West End (Landmark)

Blocks E&G Amendment – DSUP#2023-10008

Comprehensive Sign Plan – SUP#2023-00011

Planning Commission

Proposed Changes to Block E Layout

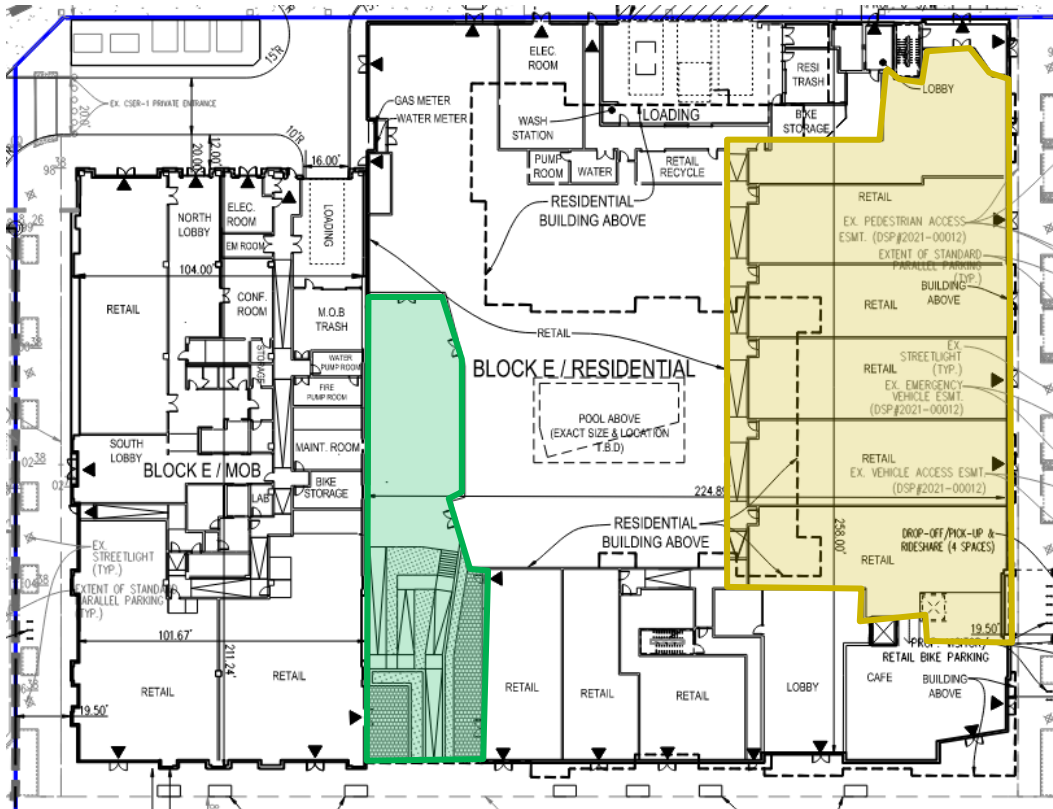
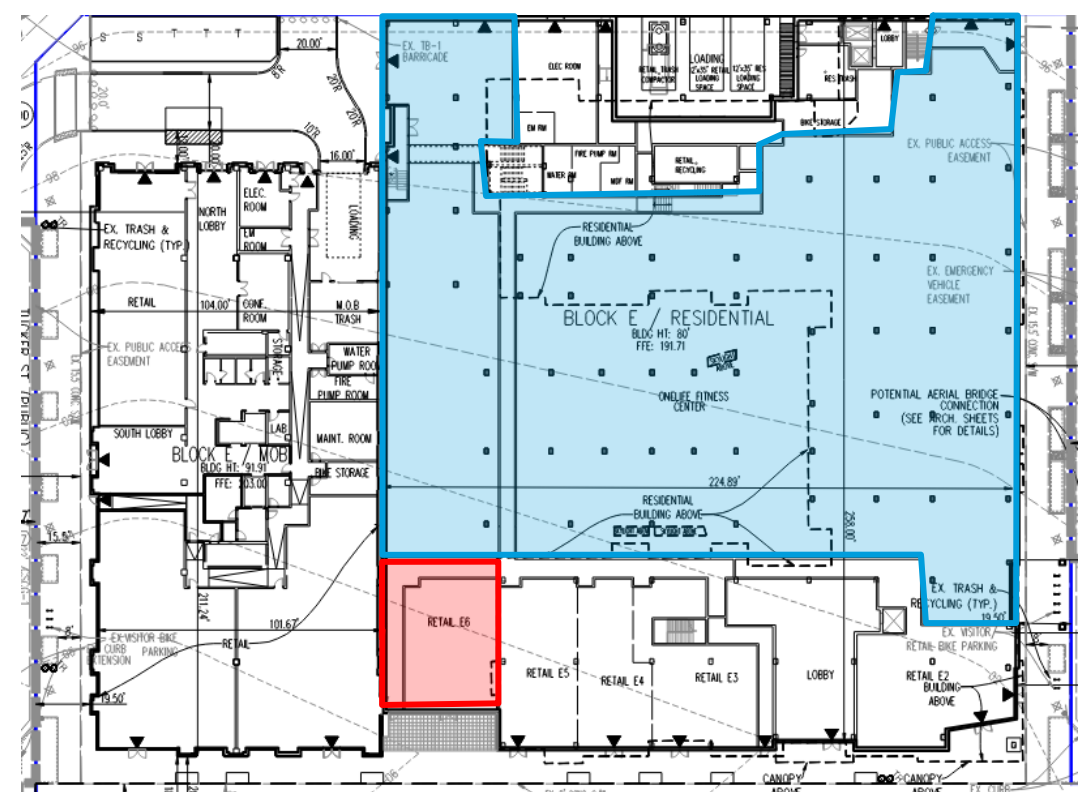
DSUP#2022-10017 **Approved Plan**

DSUP#2023-10008 **Proposed Layout**

- At-grade Courtyard
- Individual retail bays

- Enlarged retail bay with mezzanine (E7)
- New retail bay (E6)

Garage Banners Not Supported

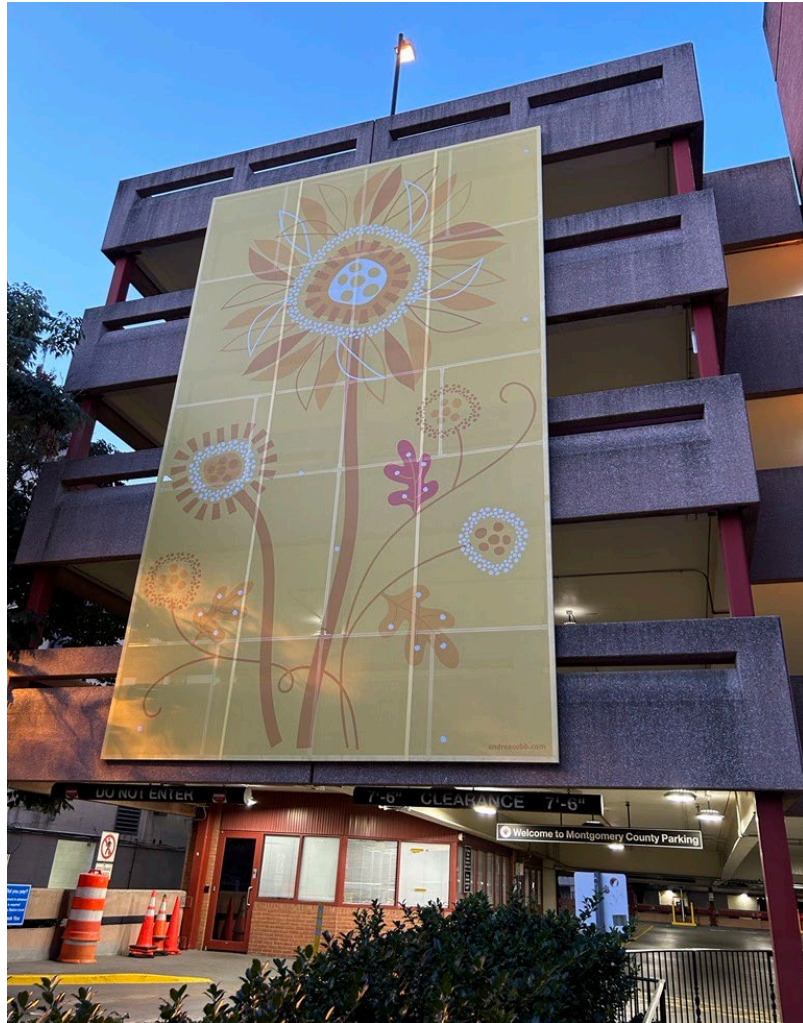
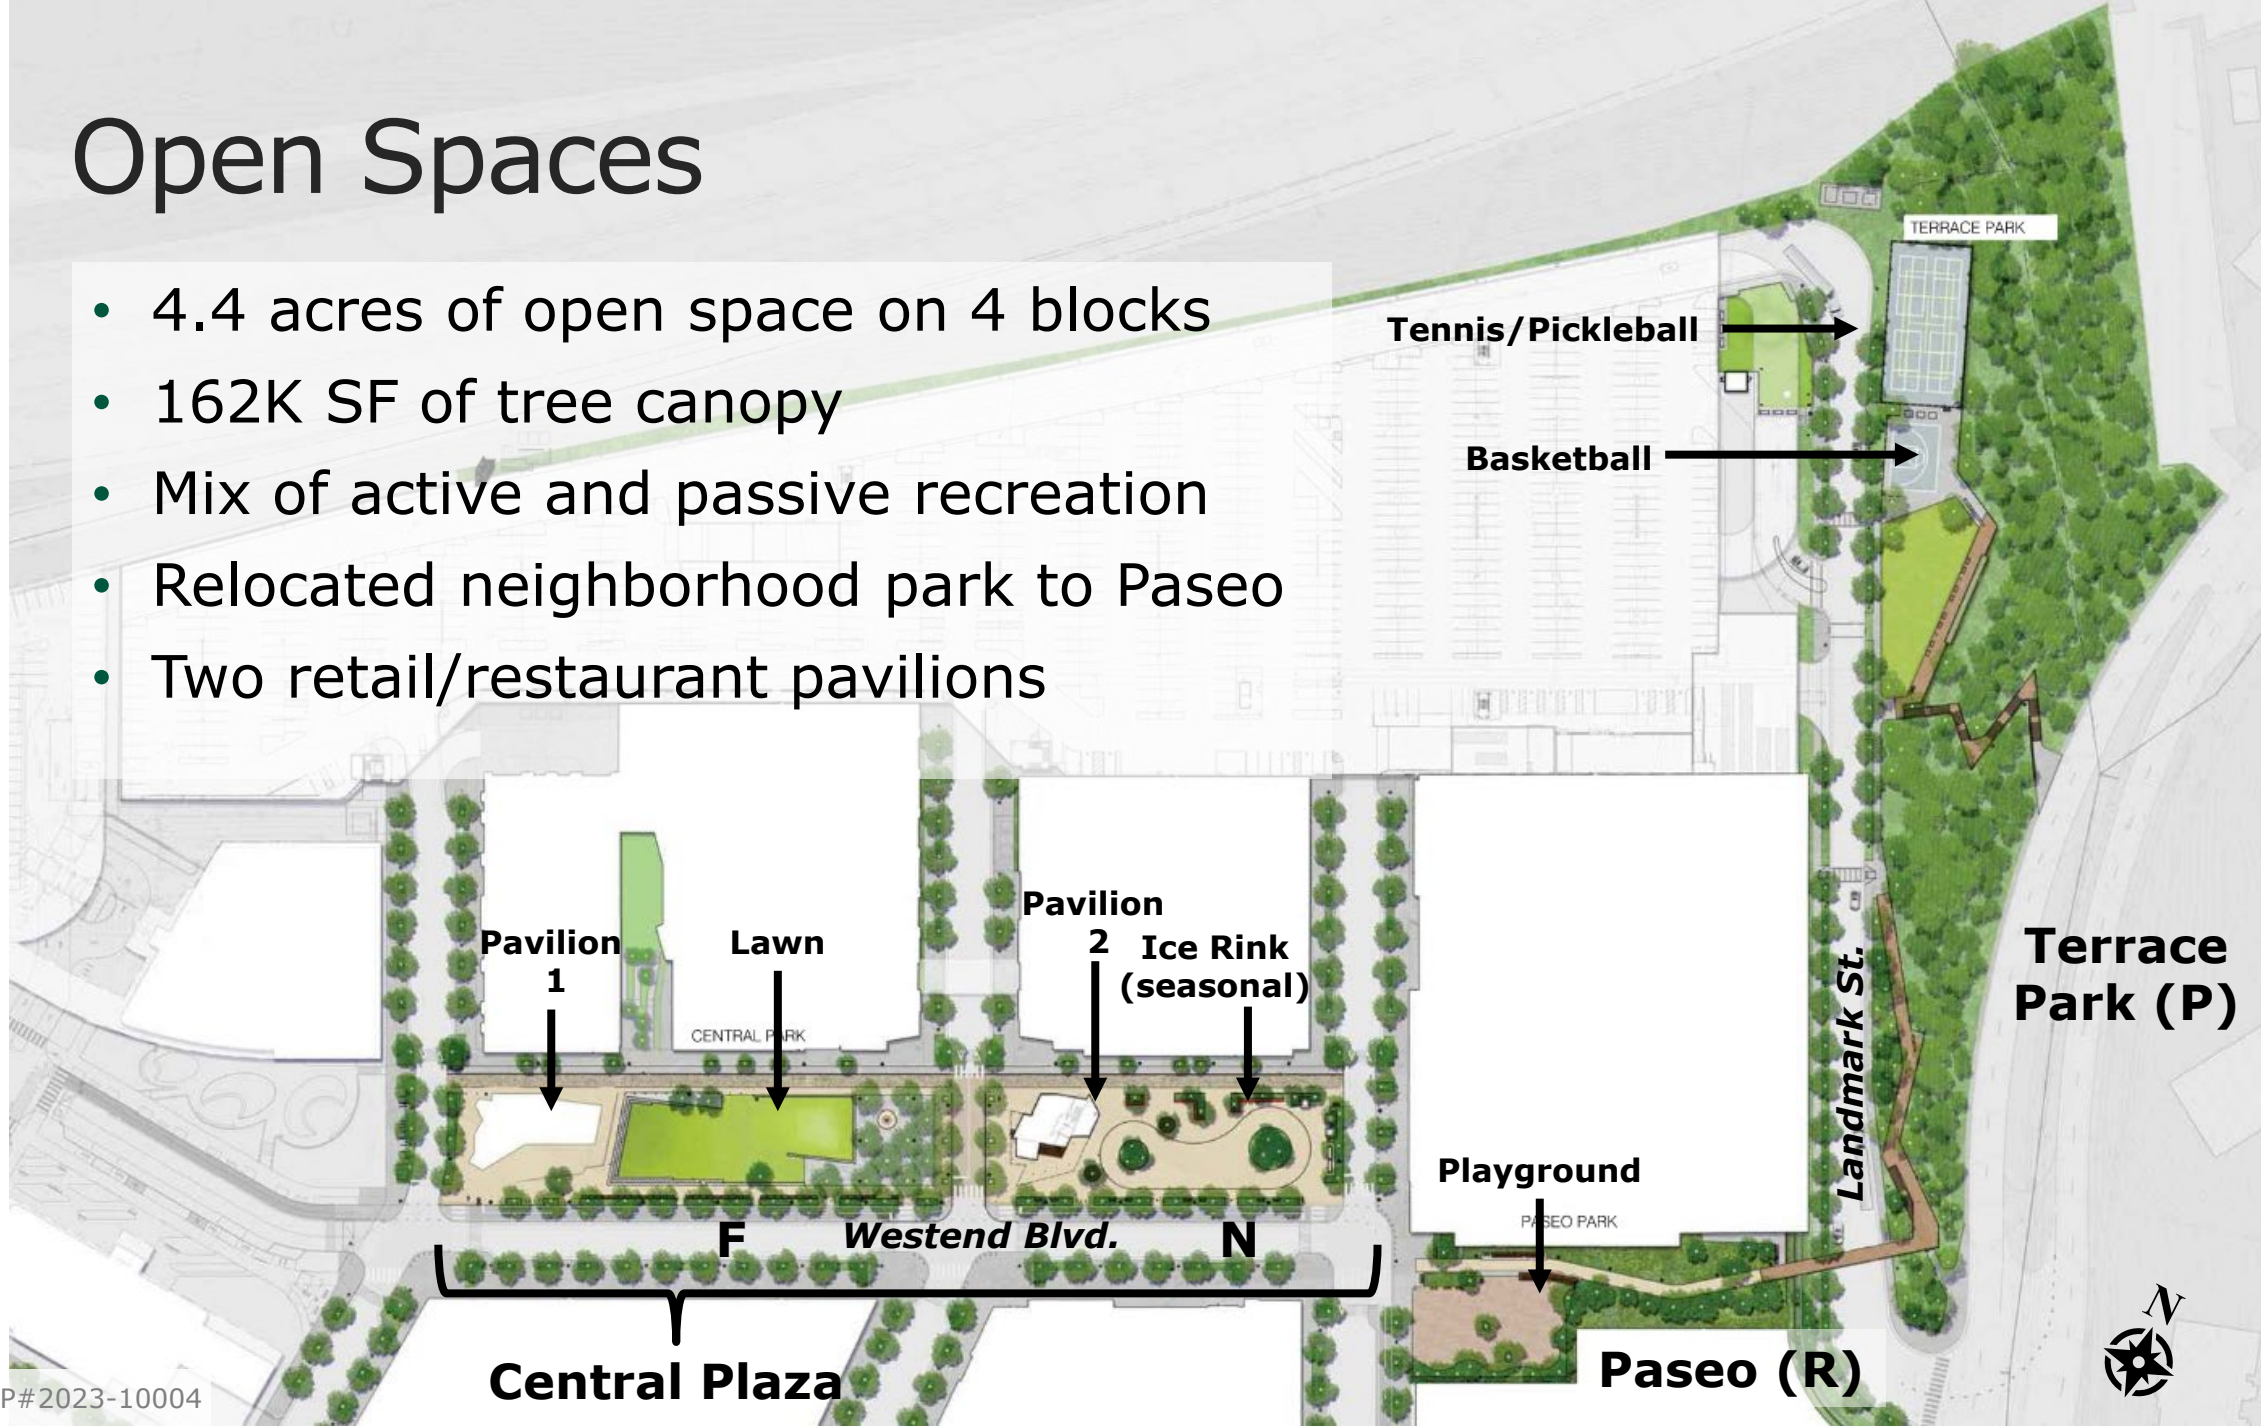
Photo from applicant of a Bethesda garage

- Proposed:
 - 12 signs (max.)
 - 100 SF (max.)
- Materials:
 - Channel letters or logos
 - Static banner elements
- Zoning Ordinance requires signs to be high aesthetic quality
- Staff supports channel letters or logos but not banners due to maintenance concerns
